**FILE NO.:** HR 17-04: Historic Review for a new Public Works Operations facility in the McLoughlin Conservation District.

**REQUEST:** Proposal for construction of a new operations facility for the Oregon City Public Works Department in the McLoughlin Conservation District.

**HRB DECISION:** Approved With Conditions

Recommended Conditions of Approval  
Planning File HR 17-04

Phase 1 Demolition Plan

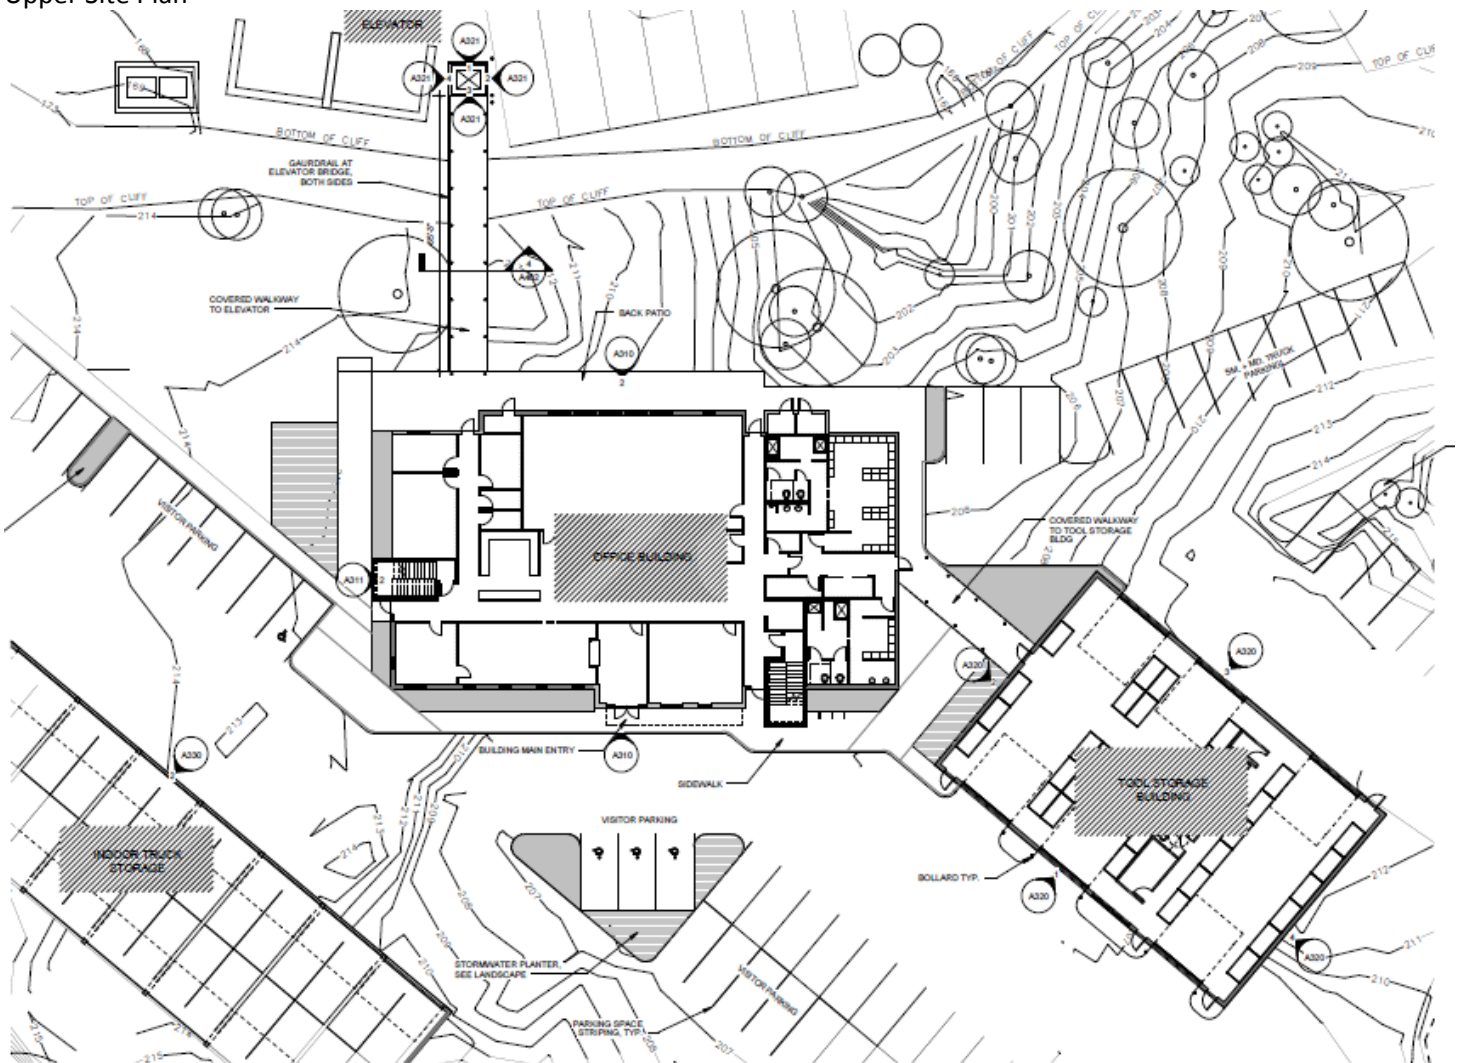
**Finding: Complies with Conditions.** The applicant proposed demolition of multiple structures onsite, primarily in the upper yard, as identified in the attached demolition plan.

In order to mitigate the removal of the Camp Adair buildings, the applicant shall coordinate with the City to send out a public notice in the local newspaper for any parties interested in removing and rehabilitating the Camp Adair buildings. Further, the 2009 Master Plan approval identified the following conditions that will remain unaltered and in effect, notwithstanding this approval:

## Upper Lot Planting Plan

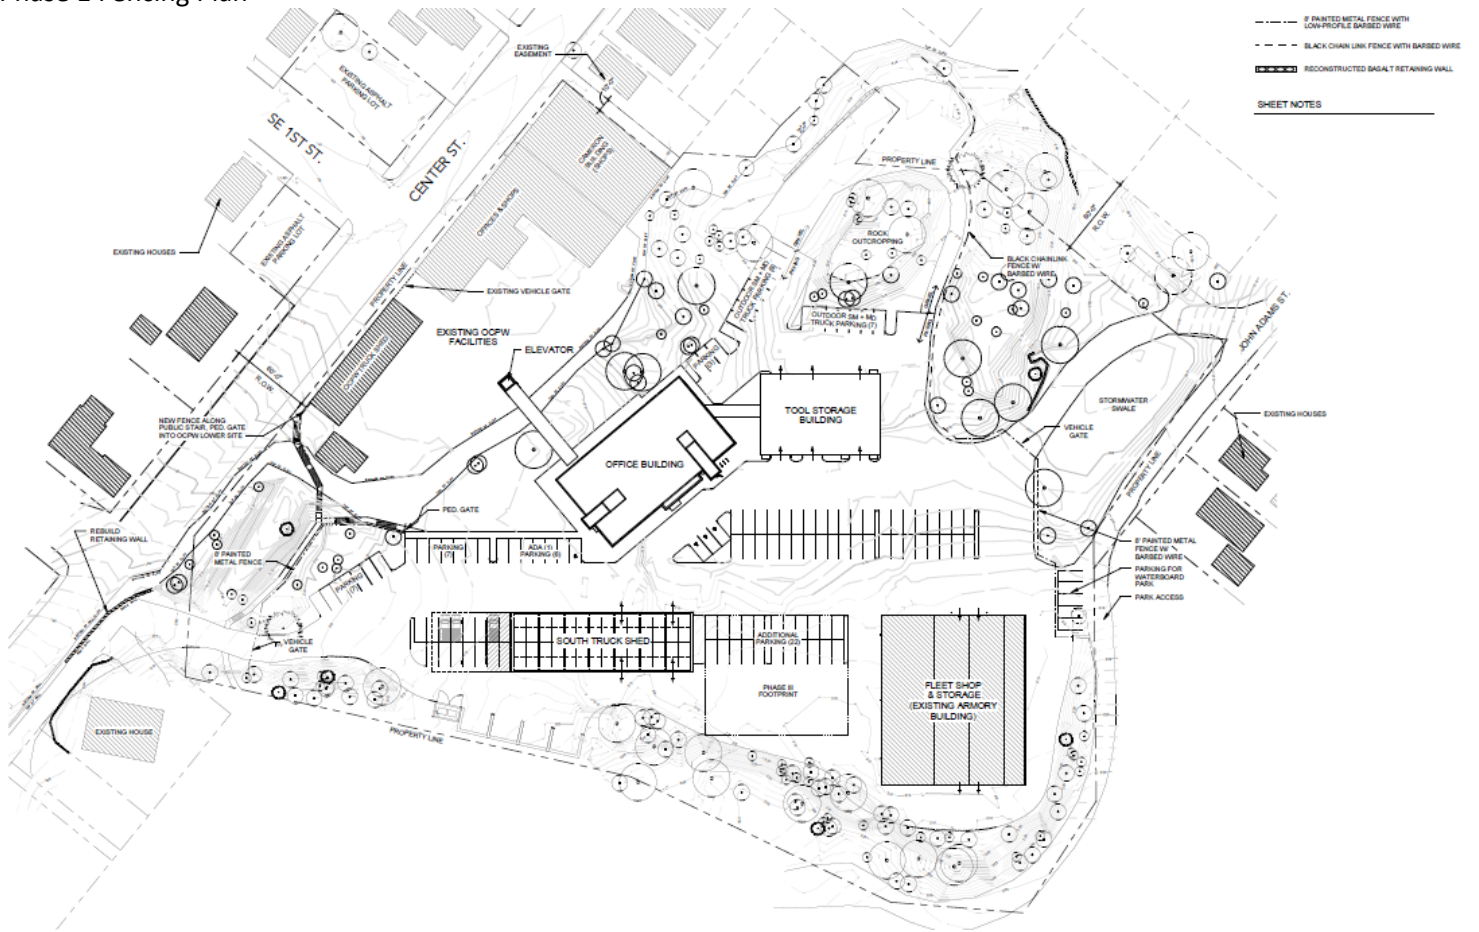
**Finding: Complies with Condition.** The applicant appears to have 20% of the lot landscaped as identified on sheet L100 and L101, but the calculation was not provided. Prior to issuance of a permit associated with the proposed development, the applicant shall submit documentation demonstrating that a minimum of 20% of the site is landscaped. **HRB has determined that it is possible, likely and reasonable that the applicant can meet this standard through the Conditions of Approval.**

2. The applicant shall submit a landscaping plan with the following changes:
  - a. Documentation indicating that a minimum of 20% of the site is landscaped.(P)

- b. At least four (4) native trees, at least 15 feet in height when mature, and eight (8) shrubs (at least 3 ½ feet in height when mature, shall be planted along the northwest façade of the two story office building facing the South Center Street Right-of-Way.(P)

## Center Street Siteline Diagram

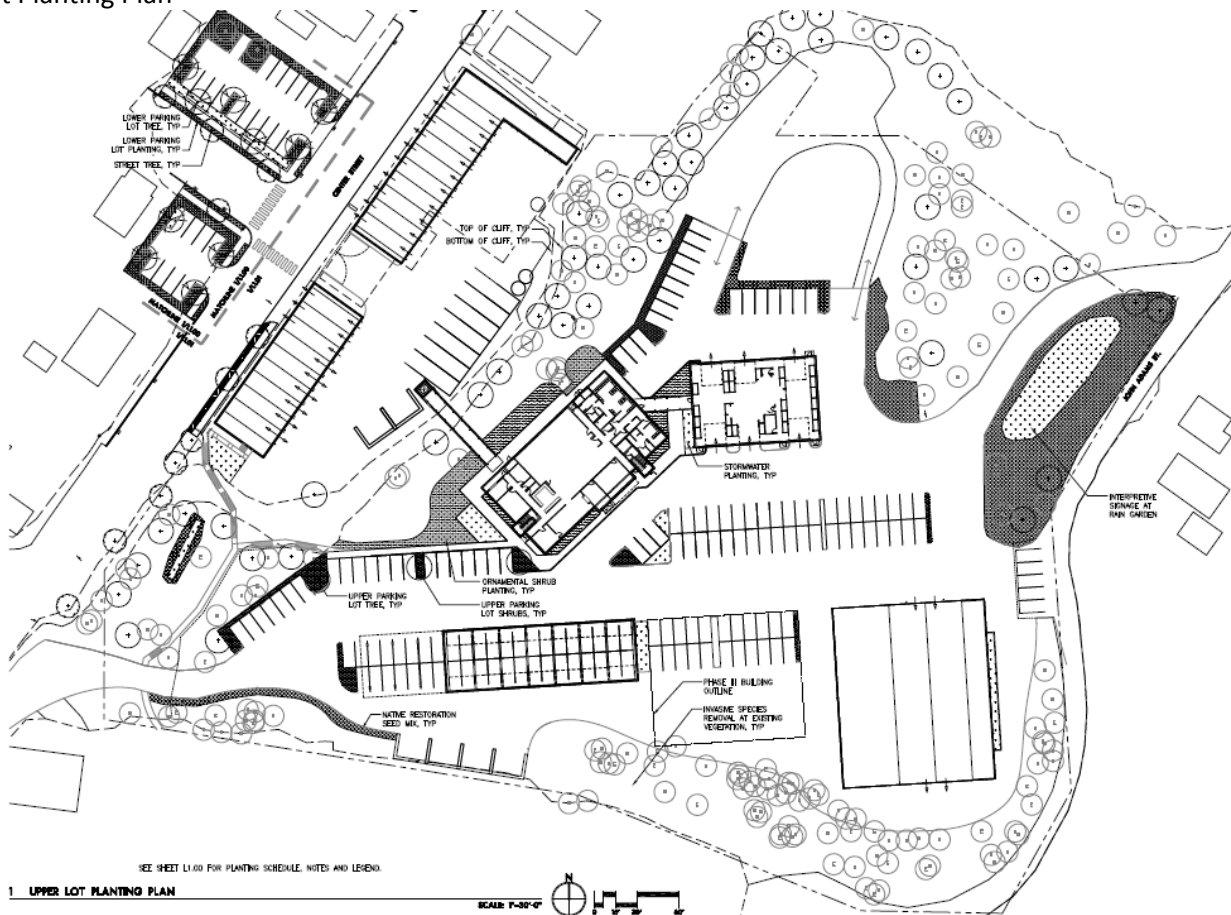
The office building will be located approximately 180 feet setback from South Center Street, atop the bluff that creates a dramatic change in elevation on the site. The applicant included line of sight drawings for the new development and they show the new office building will be able to be seen from S. Center Street, but will be designed to be cohesive with the district. The applicant has addressed this factor and used appropriate methods outlined in the Design Guidelines to mitigate for massing caused by the proposed structure.

Elevator

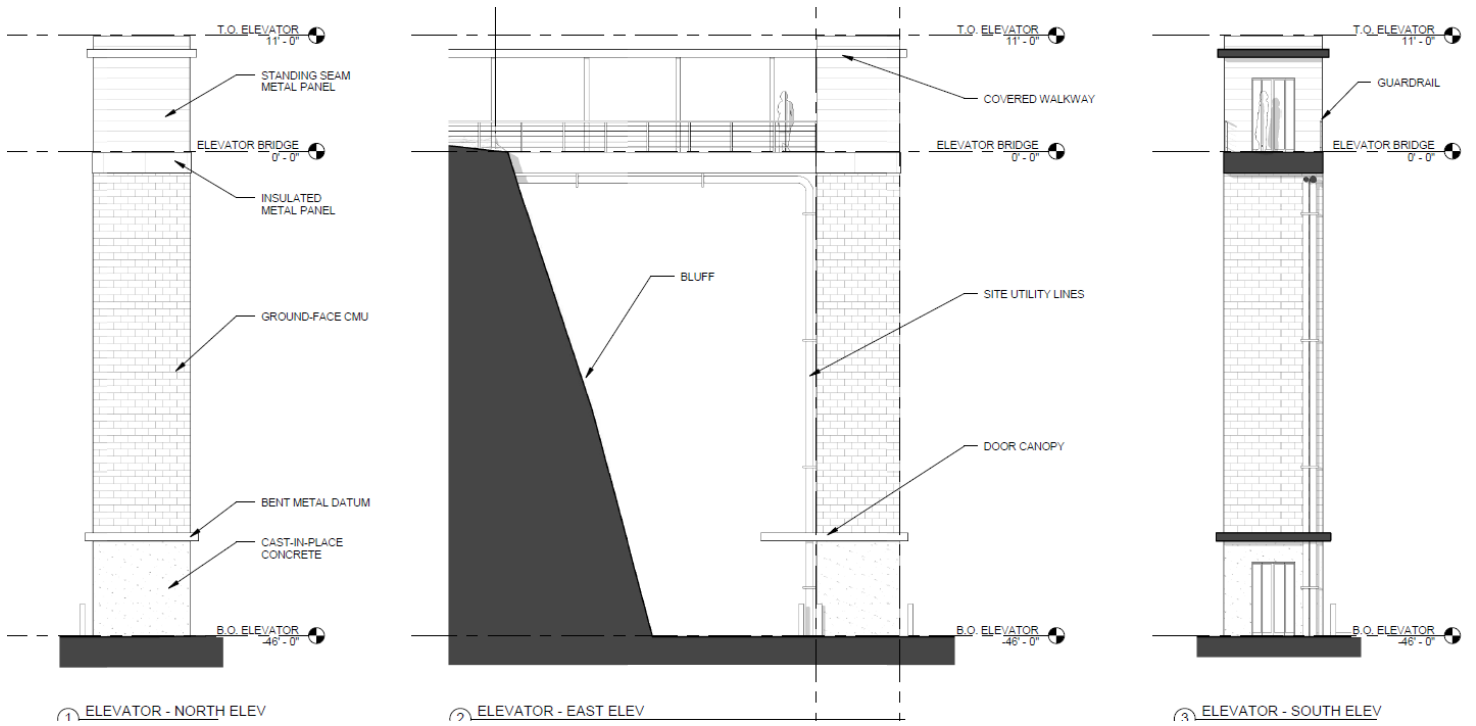
6. The materials on the elevator shall be comprised of the same materials proposed to be used on the building. Those materials include stone and metal exterior façade pieces designed in neutral and soft earth tones colors.
